AMENDMENTS TO THE DRAWINGS:

REMARKS

Claims 1-9, 11-23 and 26-33 are pending in the application.

Fig. 1

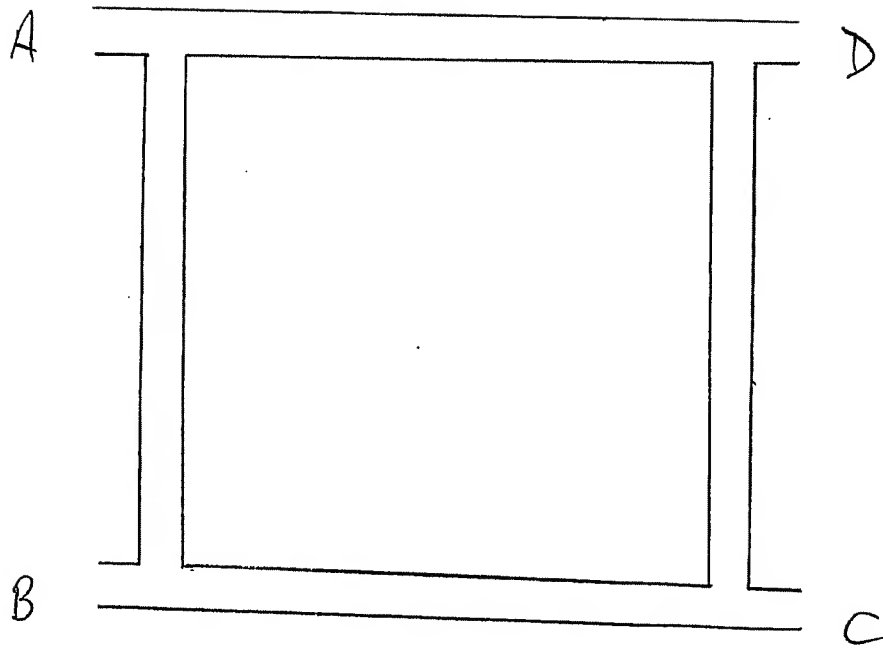
13. A second contribution to phase spoiling for Thomas 72 arises as follows. A physical view of each of the hybrids 174A and 174B in Figure 7 of Thomas 72 appears in Figure 1 of the first drawing sheet accompanying this ANNEX. Each of these hybrids is square in shape with inputs **A** and **B** and outputs **C** and **D** connected to one pair of adjacent central antenna elements E5/E6 or E7/E8 (not shown). At operating frequency, each side of the

square is $\frac{1}{4}\lambda$ long or 90° in terms of phase change: this phase change is relative between outputs, it being necessary to apply 180° to get absolute phase.

14. Input A is isolated from input B, and a signal which is input at A is equally split between outputs C and D. A signal passing along one side of the square from input A to output D has 90° phase change, but along two sides of the square from input A to output C a signal has 180° phase change. Similarly a signal passing from input B to output C has 90° phase change, but a signal passing from input B to output D has 180° phase change.
15. Let V_A and V_B be signals input to A and B respectively, ω be signal angular frequency, and V_C and V_D be signals output at C and D respectively.

Fig.9.

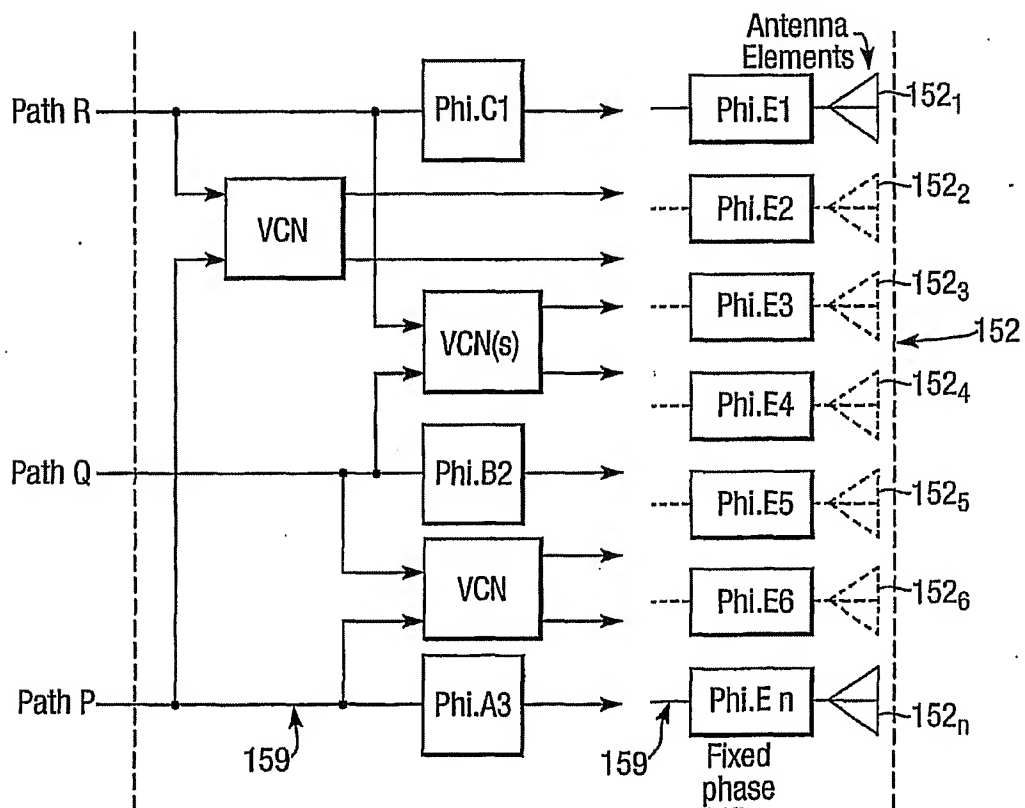
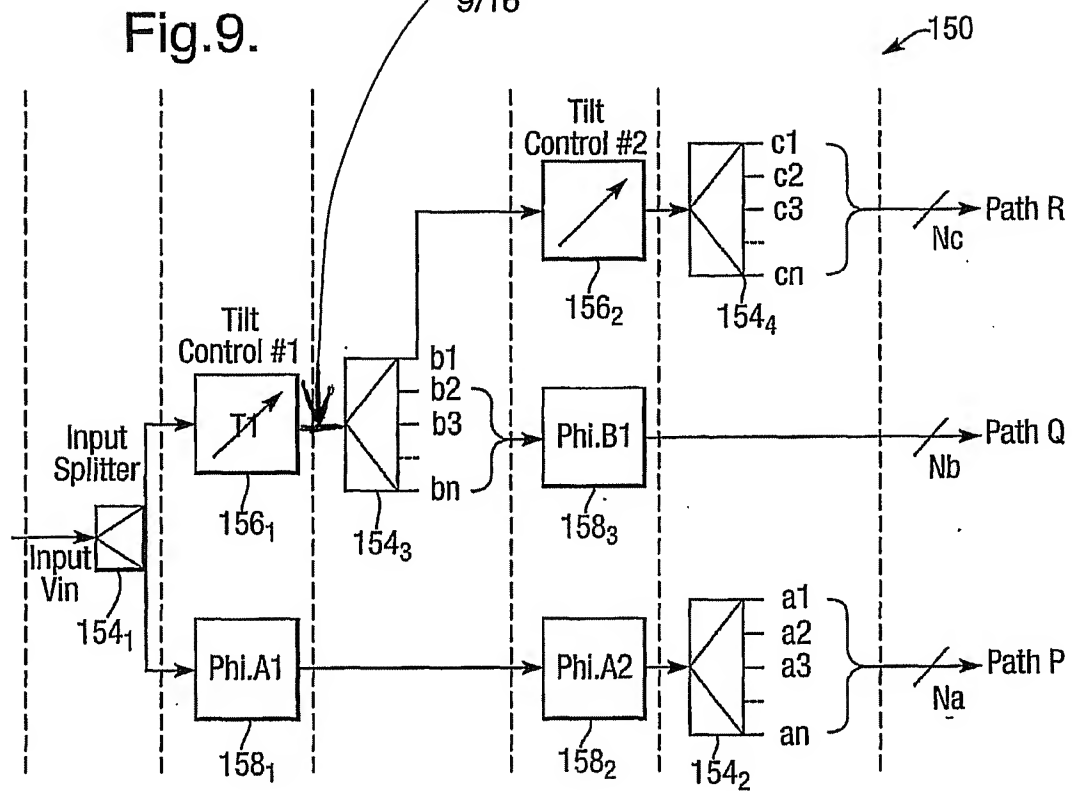
The attached drawing sheets include marked up and clean amended versions of Figure 9. Figure 9 is amended to insert a missing link between the center of the vertical right hand side of tilt control 156₁ and the center of the vertical left hand side of splitter 154₃. This amendment to Figure 9 finds support in at least Figure 3 which shows the same link between tilt control 46 and splitter 52.

link to be inserted
